Change Notice

WT Series

Changes to Lever Base, Stopper & Guide on Single Pole Models

Cross Section of Changes to WT Single Pole Toggles

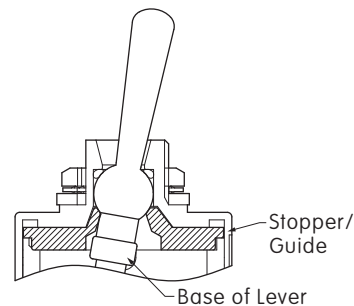
The WT Series single pole toggles will have internal changes to the base of the lever, the stopper and the guide. The stopper and guide will be constructed as a single unit. These changes will effect all single pole models, both standard and custom. The following tables illustrate the differences before and after the modifications, and the standard part numbers effected by the changes.
